CITY OF MARION, IOWA

SUPPLEMENTARY SPECIFICATIONS TO SUDAS

These Supplementary Specifications amend or supplement the Statewide Urban Design and Standards (SUDAS) and other provisions of the Contract Documents as indicated below. All provisions which are not so amended or supplemented remain in full force and effect.

Exhibit A

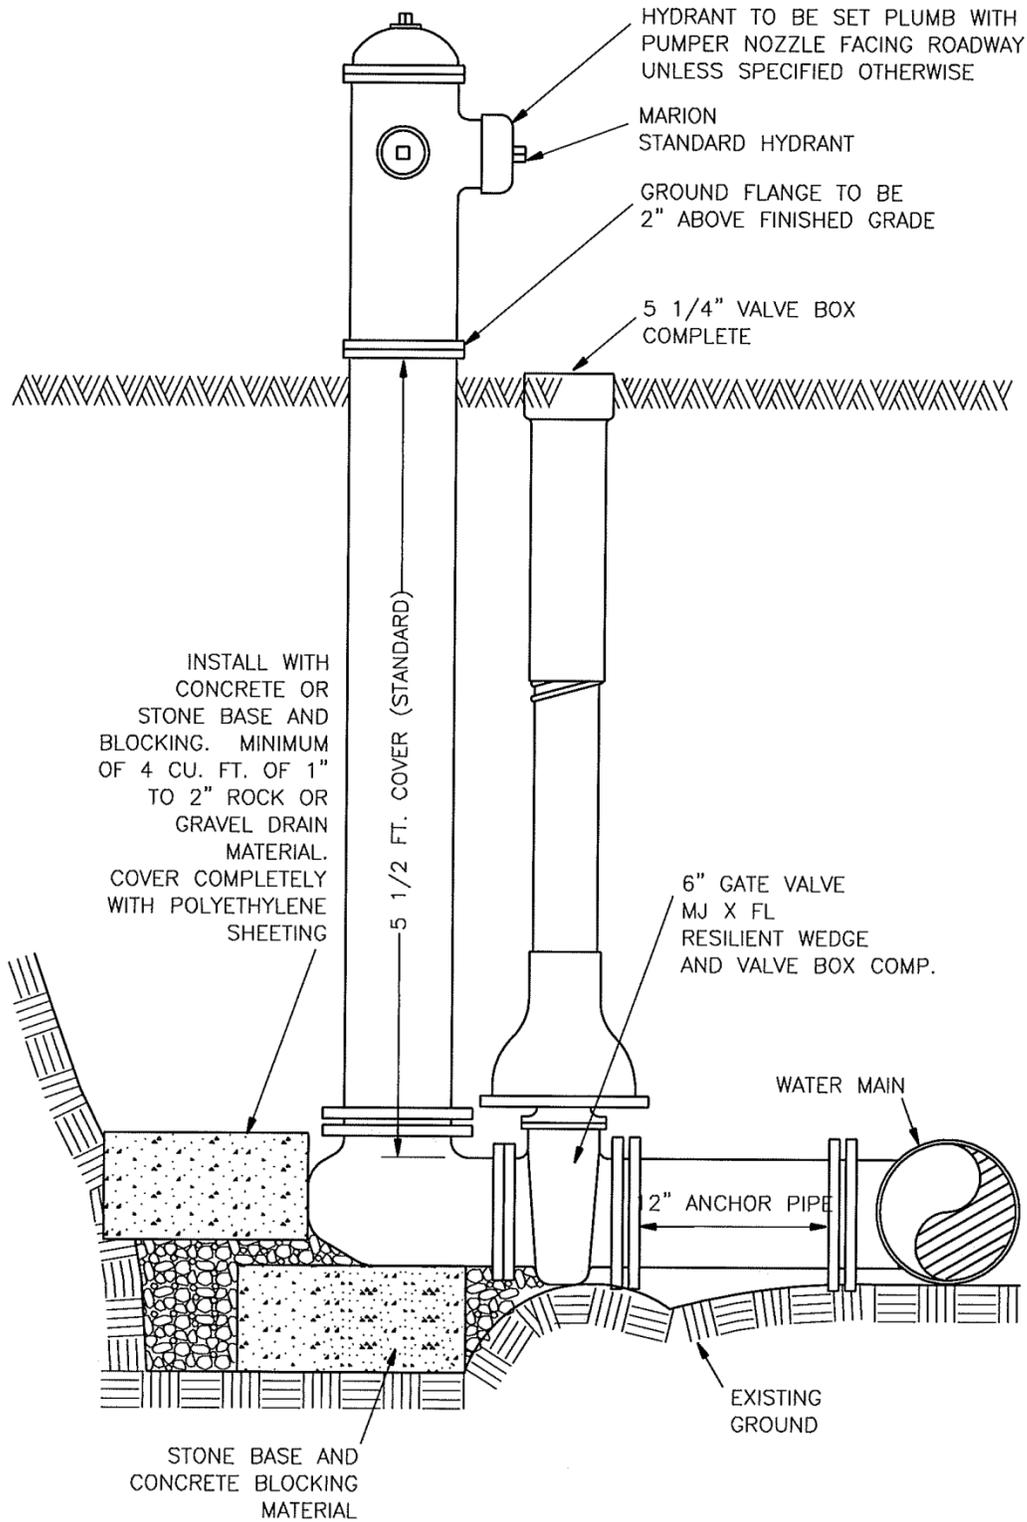
A. “Figure 5020.201”

F. Entirely

A. “Exhibit A & B”

F. Orientation of Fire Hydrant nozzles done by Water Department

Exhibit B

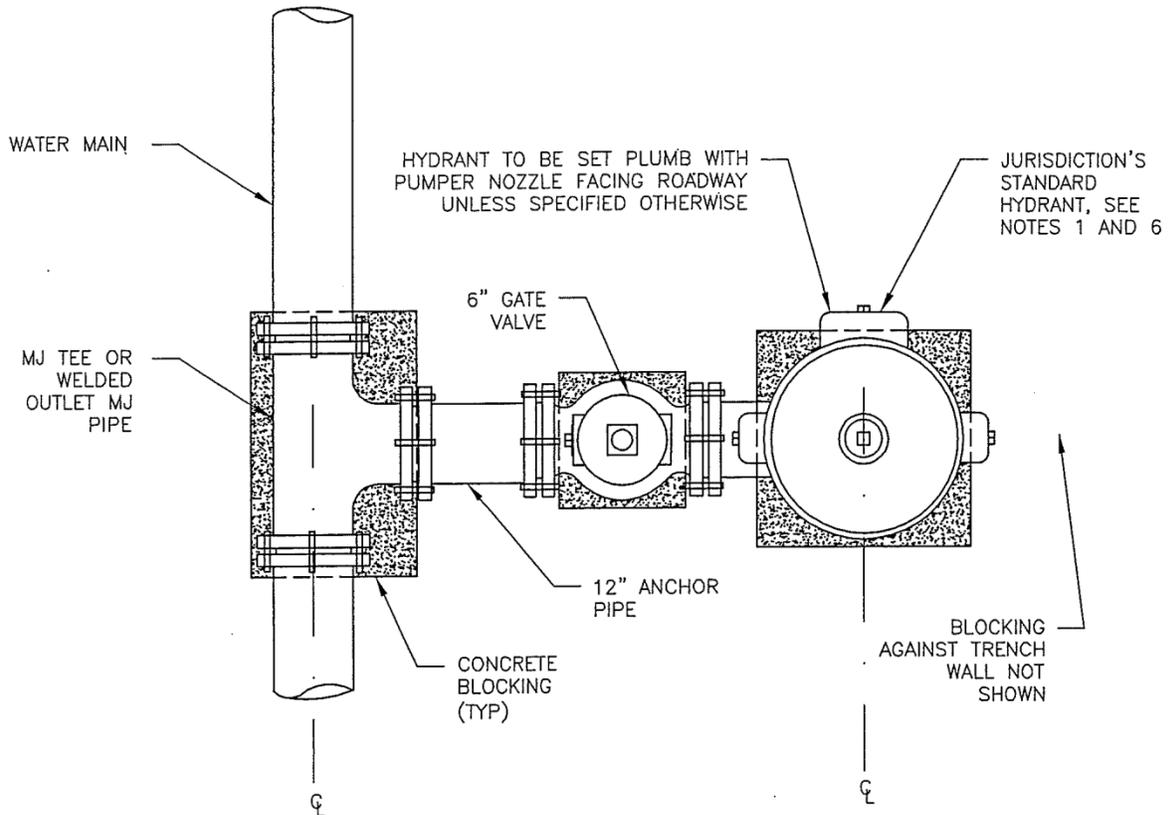
See detail - Fire Hydrant Exhibit A & B – Type II – Marion”

Exhibit C

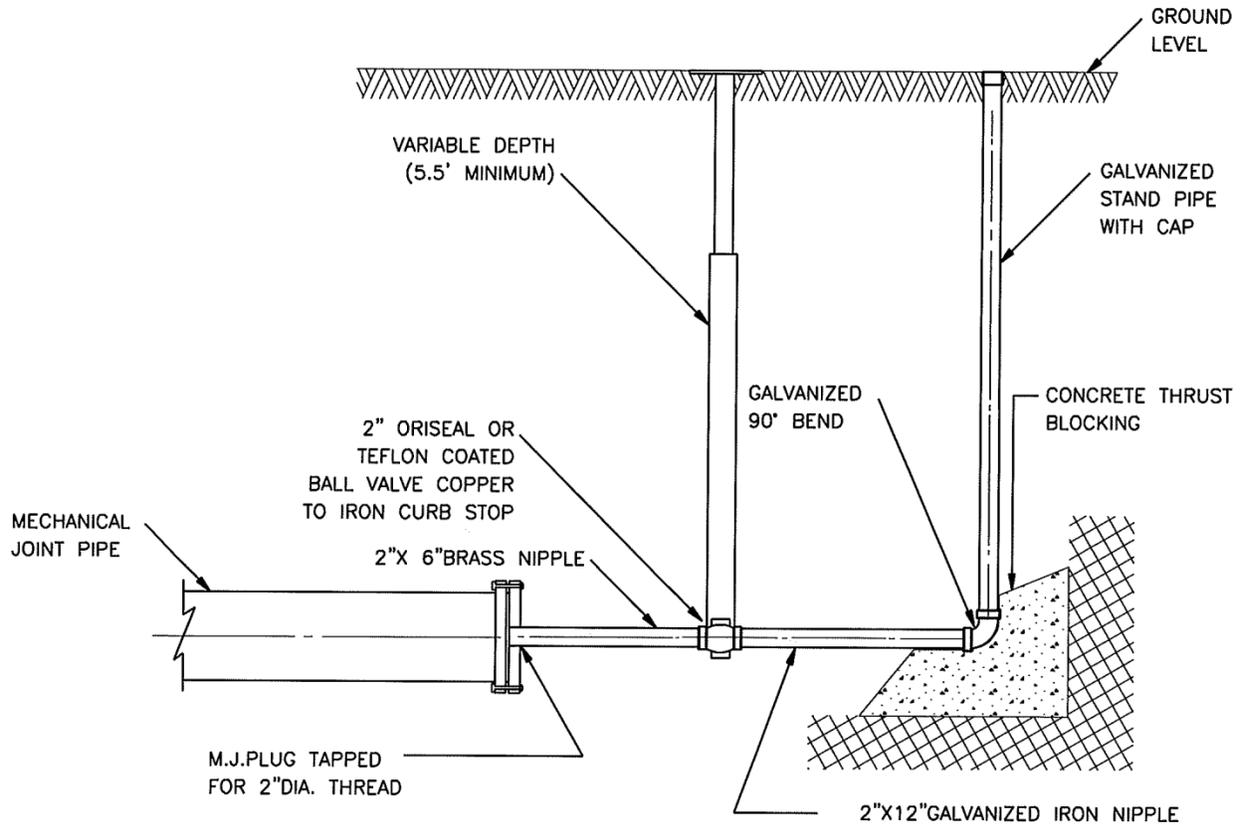
“See Exhibit C – Blow off Detail”
